Access Compliance Report

Public Rights-of-Way

Intersection ID: 2683	Main Street: FAIRVISTA_DR	Cross Street: REGAL_CT	Location: NE
ADA ID: B8BD58B793F0	Ramp Type: BlendTrans1	Initial Pass/Fail: Fail	Overall Compliance: No
			Severity Score: 21.25

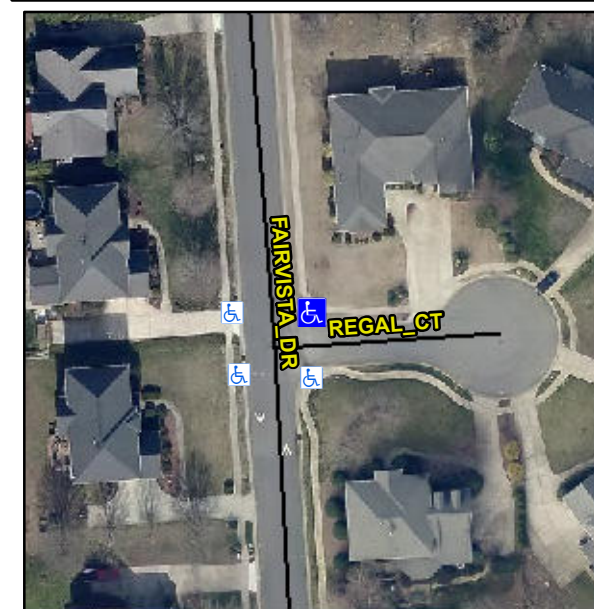
Not Found, R304.5.1, R304.5.3

Compliance	Description	Data	Compliance	Description	Data
N/A	Ramp Length (in)	47.5	Yes	BlendTrans Slope (%)	4.3
No	Ramp Width (in)	44.0	No	BlendTrans XSlope (%)	5.1
N/A	Flare Type LT	N/A	N/A	Flare Type RT	N/A
N/A	Flare Slope LT (%)	N/A	N/A	Flare Slope RT (%)	N/A
N/A	Flare Traversable LT?	N/A	N/A	Flare Traversable RT?	N/A
N/A	Landing Length (in)	N/A	N/A	DWS Provided?	N/A
N/A	Landing Width (in)	N/A	N/A	DWS Contrast?	N/A
N/A	Landing Slope (%)	N/A	N/A	DWS Length (in)	N/A
N/A	Landing X Slope (%)	N/A	N/A	DWS Full Width?	N/A
N/A	Landing Curb? (Y/N)	N/A	N/A	DWS Offset (in)	N/A
N/A	Shared Landing?	N/A			
N/A	Gutter Ponding?	N/A	N/A	Gutter Slope (%)	N/A
N/A	Gutter Lip Ht (in)	N/A	N/A	Gutter X Slope (%)	N/A
N/A	Painted X Walk1?	No	N/A	Painted X Walk2?	No
	X Walk 1 Direction	To W		X Walk 2 Direction	To S
	X Walk 1 Width (in)	N/A		X Walk 2 Width (in)	N/A
	X Walk 1 Slope (%)	3.2		X Walk 2 Slope (%)	0.2
	X Walk 1 X Slope (%)	2.9		X Walk 2 X Slope (%)	3.1

N/A	Ramp inside XWalk1?	N/A	N/A	Ramp inside XWalk2?	N/A
	Road Slope (%)	4.0		Clear Space?	N/A
	Road X Slope (%)	0.0	N/A	Clear Space to XWalk (in)	N/A
N/A	Any Obstructions?	N/A	N/A	Storm Grate/Utility Hazard?	N/A
	Obstruction Type			Storm Grate/Utility Type	
		N/A			N/A
			Yes	Surface Condition? (G/P)	Good
			No	Curb Slope (%)	12.1

Remove & Replace Curb Ramp With Two New Directional Ramps or Equivalent.
